Groundwater Application Review Summary Form

Application # G- <u>/8772</u>	
Application # G- 18772 GW Reviewer Travis Brown	Date Review Completed: 5/3/2019
Summary of GW Availability and Injury Review:	
[] Groundwater for the proposed use is either over amounts requested without injury to prior water rigil capacity of the groundwater resource per Section B of	hts, OR will not likely be available within the
Summary of Potential for Substantial Interference F	Review:
There is the potential for substantial interference	e per Section C of the attached review form.
Summary of Well Construction Assessment:	
[] The well does not appear to meet current well co review form. Route through Well Construction and C	·
This is only a summary. Documentation is attached a basis for determinations and for conditions that may

PUBLIC INTEREST REVIEW FOR GROUNDWATER APPLICATIONS

TO: FROM	1:		r Rights Sondwater So	ection ection		Date 5/3/2019 Travis Brown Reviewer's Name Supersedes review of							
SUBJI	ÉCT:	Appli	cation G-	18772		Sup	persedes	review of _	-		Date of Rev	view(s)	
OAR 6 welfare to deter	590-310-13 e, safety and rmine whe sumption of	30 (1) 7 ad heal ther the criteria	The Departi th as

Stream Depletion Analysis - POA 1:SW 1

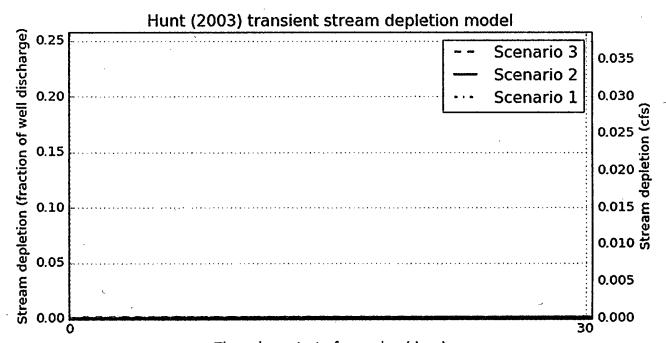
Potential depletion of SW 1-3 due to pumping of the proposed POA was estimated using the Hunt 2003 analytical model. Hydraulic parameters used for the model were derived from regional data or studies of the hydrogeologic regime (Pumping Test Reports; Water Well Reports; Conlon el al., 2003, 2005; Iverson, 2002; McFarland and Morgan, 1996; Woodward et al., 1998) or are within a typical range of values for the parameter within the hydrogeologic regime (Domenico and Mifflin, 1965; Freeze and Cherry, 1979) (see attached Stream Depletion Analyses). To be conservative, the total volume requested (72 af) was pro-rated over the requested period of use (March 1 through October 31 = 245 days) for an effective pumping rate of ~0.15 cfs (~67 gpm).

The Hunt 2003 model results indicate that depletion of (interference with) SW 1-3 due to pumping of the proposed POA is anticipated to be much less than 25 percent of the well discharge at 30 days of continuous pumping. This is most likely due to the substantial thickness of fine-grained sediments underlying the nearby surface water sources creating a highly inefficient hydraulic connection.
